Report No. PDS19-063

#### **Church Street Parking (Library Square)**

#### **Public Open House Summary**

Figure 2: Option 1

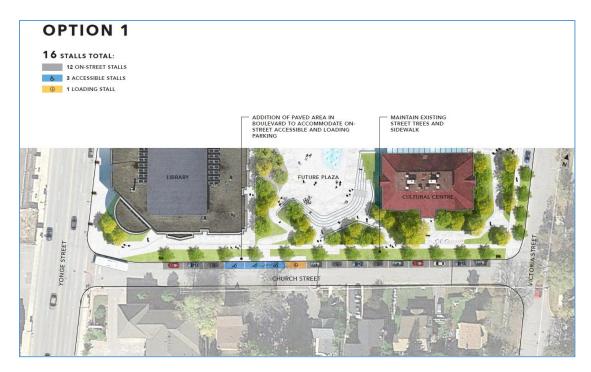
- This option is preferable as it maintains the existing street trees;
- Consider a secondary entrance to the south-east corner of the library for easier access from Church Street;
- Widen the intersection at Yonge Street and Church Street to accommodate bus turning movements;
- Focus on changing behaviours and get people walking rather than adding more parking spaces for cars;
- Consider converting on-street parking on Yonge Street to a 15-minute drop off to take advantage of the accessibility ramp connecting to the west entrance of the Library; and
- Make sure there are enough drop-off spots per building (Library, Cultural Centre, and the new Community Facility).

Figure 3: Option 2A

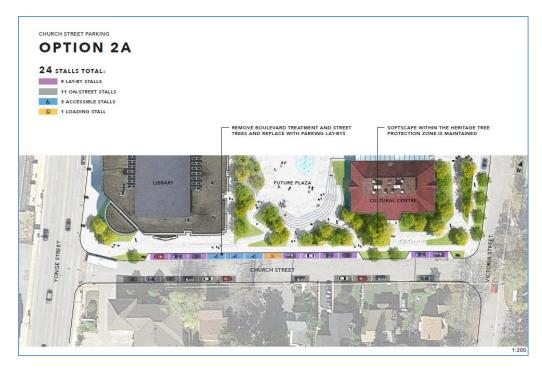
- Like pathways through the site that connect to places and streets;
- Consider moving the existing bus stop at Church Street and Yonge Street to a safer location;

- Limit street parking on Yonge Street;
- Consider changing Church Street to one-way movement;
- Take away the left turn movements from Church Street onto Yonge Street to promote safer vehicular and pedestrian movement at this intersection;

- Consider 'bump-outs' along the layby to provide space for street tree plantings;
- Provide 2 loading and drop-off/pick-up spaces;
- This option changes the character of houses on the south side of Church Street. Clarify if the houses are offices or homes. The use makes a difference in terms of the level of impact;

- There are not enough parking spots or enough room for emergency services;
- There is currently a lot of through traffic on Church Street;
- Parking on the south side of Church Street will increase pedestrian movement in a southnorth and north-south direction across the street. Make sure there are plenty of safe pedestrian crossing;

- Do a survey to see where cars in the library parking lot are currently coming from and consider parking study on a Sunday to monitor church activity in the parking lots and on on-street parking;

- Try Option 2A without parking on the south side of Church Street. Could monitor and implement on-street parking later, if additional parking is required;
- Option 2A looks good. If issue with south side go to option 2B;
- Make the landscaping and building a learning experience for kids; and
- Undertake an analysis of turning movements and traffic flows from existing and new uses.
